S M Knitwears Limited (Extension)

Shirirchala, Bhabanipur, Gazipur

21 January 2024

2. Observations:

Observation 2: Mismatch in as-built drawings. (Building 4)

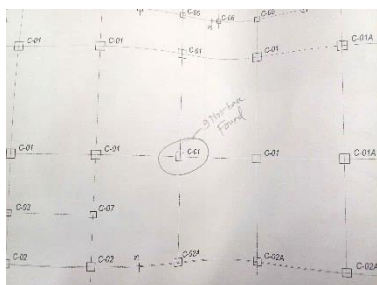
Rebar mismatch in as-built drawing

Built-up in toilet zone was not shown in as-built drawing

Description: Mismatch was found in as-built drawing of Column and toilet zone. During inspection, rebar of C-01 column was found 9-nos in one side instead of 10-nos and built-up (8") in toilet zone was not shown in drawing. The building engineer is required to revise the as-built drawing as per actual site condition.

Observation 3: Inadequate number of material test report (Building 4)

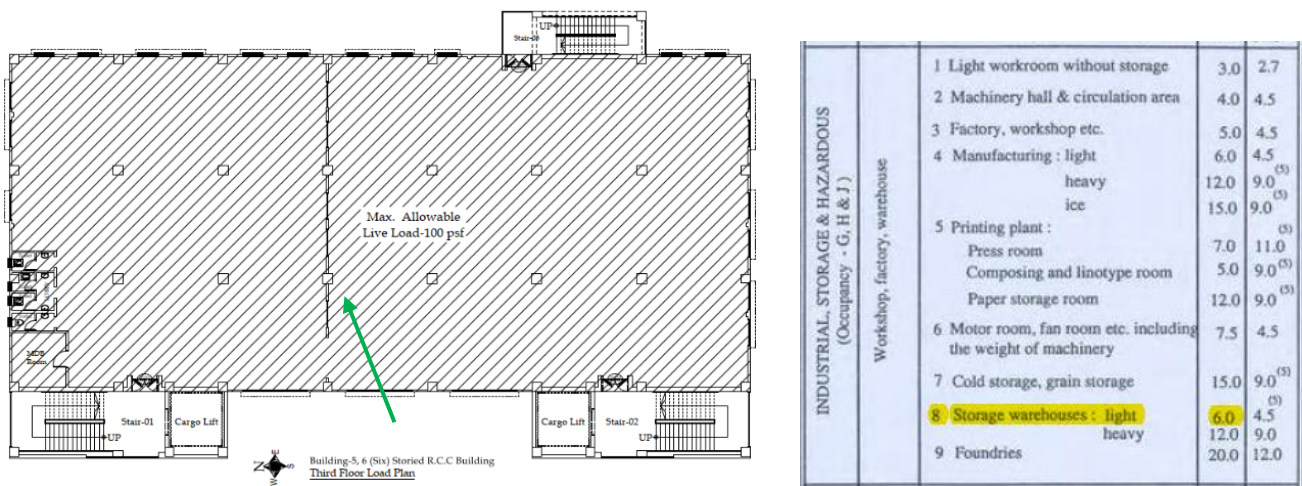
Description: As per BNBC 5.12.2 (frequency of testing) requirement, an adequate number of concrete cylinder test reports were not available onsite to meet the design strength. The building engineer is required to verify in-situ material strength by taking a minimum four number of concrete cores from the lower tier of the existing building column.

Observation 6: Unbraced storage racks (Building 5)

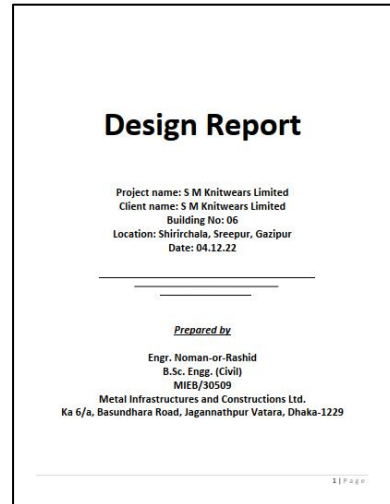
Unbraced storage racks

Description: Storage racks at several locations were found unbraced. The building engineer is required to brace/anchor all the non-structural elements including the storage racks.

Observation-12: Lack of lateral stability. (Shed 6)

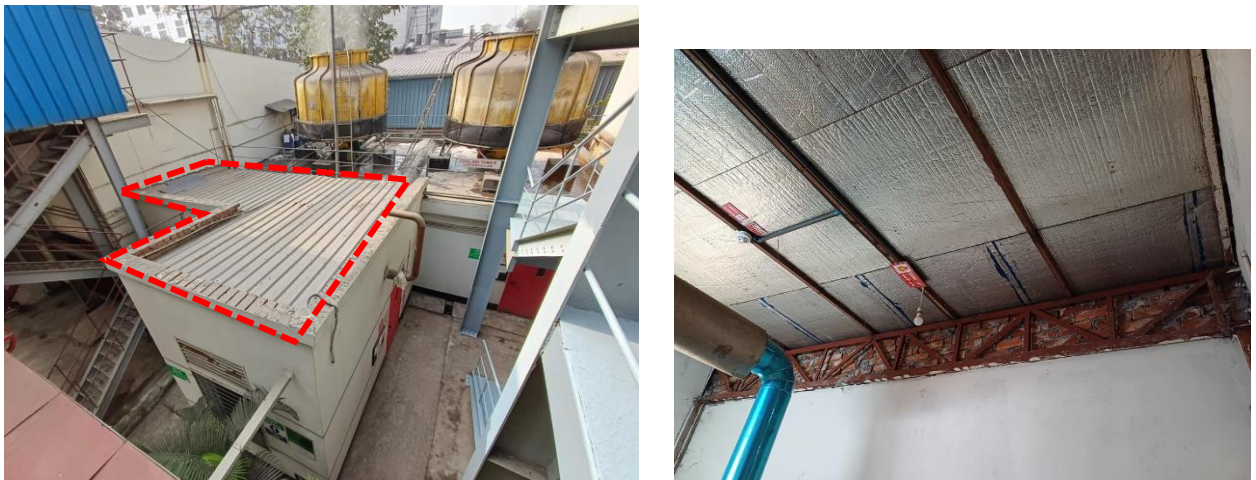
Description: Lack of lateral stability system and inadequate member sizes were observed in the structure. The building engineer is required to carry out Engineering Assessment (EA) to check the stability of the structure and suggest proper remedial actions accordingly. Submit the EA documents to RSC for review.
